GOVERNMENT OF THE DISTRICT OF COLUMBIA
DEPARTMENT OF TRANSPORTATION

MEMORANDUM

SUBJECT: **BZA Case No. 19797** – 1925 Vermont Avenue NW (African American Civil War Museum at the Historic Grimke School)

Figure 1 - Site Plan: (Source: Applicant's Architectural Plans, Exhibit 7A, dated 5/9/18)

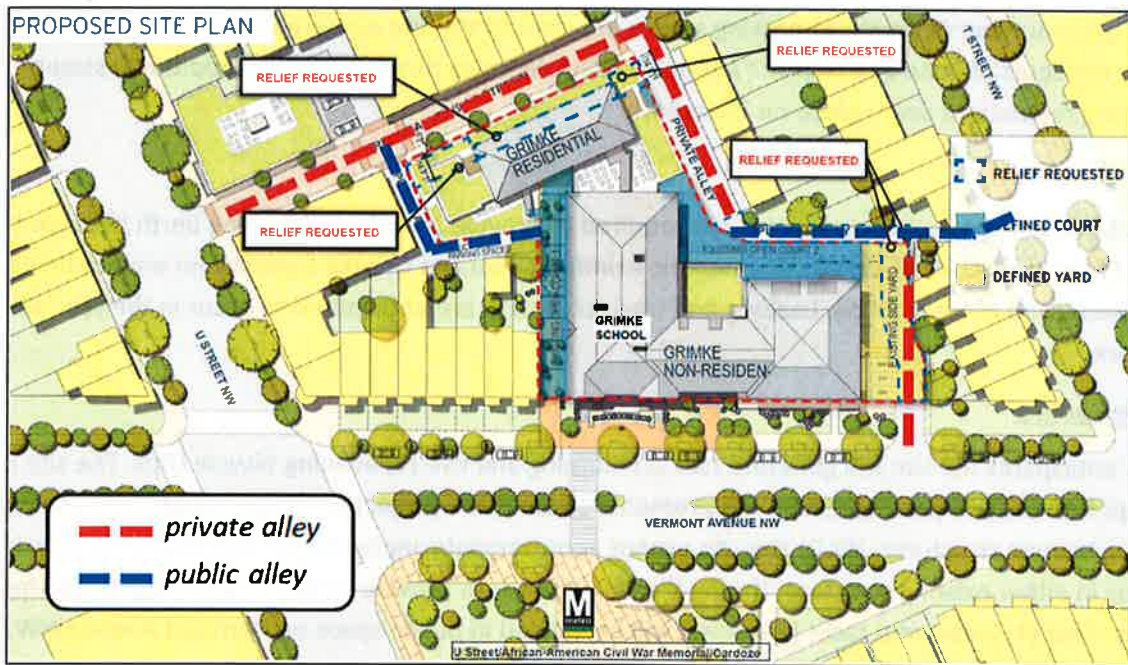
The Applicant is requesting relief to accommodate its vehicle parking. Per Subtitle C § 711.3(b), when vehicle parking spaces are accessed by a public alley, the alley must be no less than 10 feet wide. The ten surface parking spaces proposed on the east side of the Grimke school are adjacent to an alley that is 9.33-feet wide. While DDOT has no objection to this relief, DDOT notes that some vehicles—particularly larger SUVs and vans—will need to make multiple movements when moving into or out of a space. The Applicant also requests relief from Subtitle C § 712.5, which specifies the drive-aisle widths for different parking space layouts. The Applicant is proposing both perpendicular and parallel spaces adjacent to a two-way drive aisle, which must be 20-feet wide per zoning. Due to existing site constraints, the site drive aisle is 17-feet wide. While the proposed widths are not ideal for quick, convenient vehicle parking movements, vehicles should still be able to navigate within the alley.

The site currently contains 16 existing vehicle parking spaces. Per Subtitle C § 704.2, the Applicant is not required to provide additional vehicle parking spaces because the existing Grimke School and Grimke Gymnasium are not being increased by 50 percent (50%) or more. Despite this, the Applicant proposes to provide 21 vehicle parking spaces accessible via 9½ Street NW, an alley with both public and private segments, as shown in Figure 1. The layout provides both perpendicular and parallel spaces.
